SERVICE BULLETIN

RN SERIES 45-130 SERIAL # 1/03-12/03 DATE/NUMBER 11/03-1

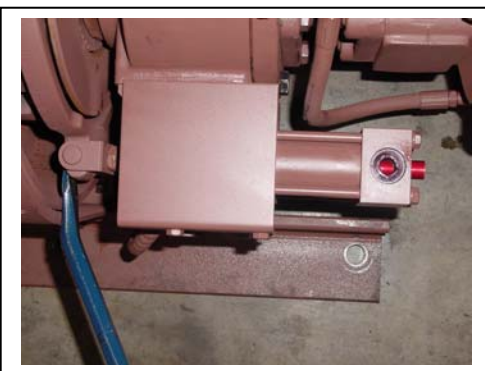
Field reports indicate that the clutch position indicator switch may be binding and causing the shaft to be gouged leading to failure of the clutch air cylinder and/or the switch. The ball on the end of the switch may be binding and not rolling up the ramp smoothly causing it to slide down the shaft leading to this failure. Inspection for this problem is as follows.

REMOVE WIRES AND SWITCH

INSPECT ROLLER BALL ON
BOTTOM OF SWITCH

WITH SWITCH REMOVED INSPECT ROD FOR WEAR IF NO WEAR IS VISIBLE LUBE ROLLER BALL WITH GREASE AND REINSTALL. IF WEAR IS EVIDENT REPLACE THE CYLINDER WITH PART# RN45-44339, RN60&100- 44340

AND THE RN130-44341. A CLAIM MAY BE SUBMITTED FOR \$25.00 USD FOR LABOR, SUPPLYING THE SERIAL NUMBER OF THE WINCH AND USING THIS SERVICE BULLETIN AS REFERENCE

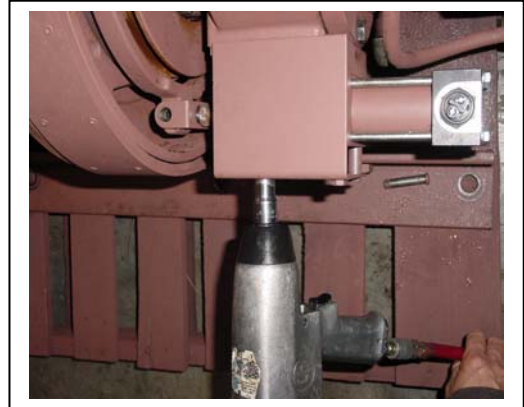
TO INSTALL THE NEW CYLINDER

HOLDING THE CYLINDER ROD
LOOSEN THE JAM NUT

REMOVE THE PIN, AIRLINES
AND THE CYLINDER

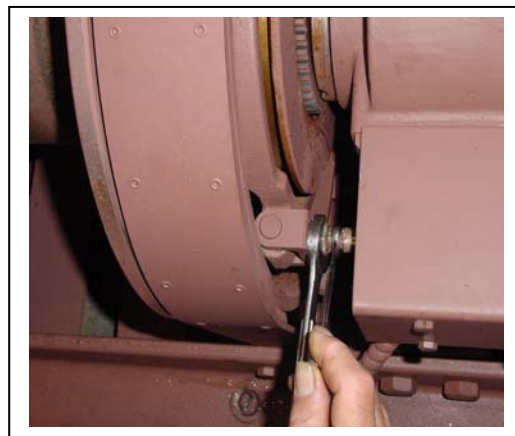
REINSTALL THE AIR CYLINDER
AND WHILE PUSHING ON THE
CLUTCH YOKE INSURE THAT THE
PIN DROPS IN FREELY

TIGHTEN THE JAM NUT AND
CHECK OPERATION OF THE
CLUTCH
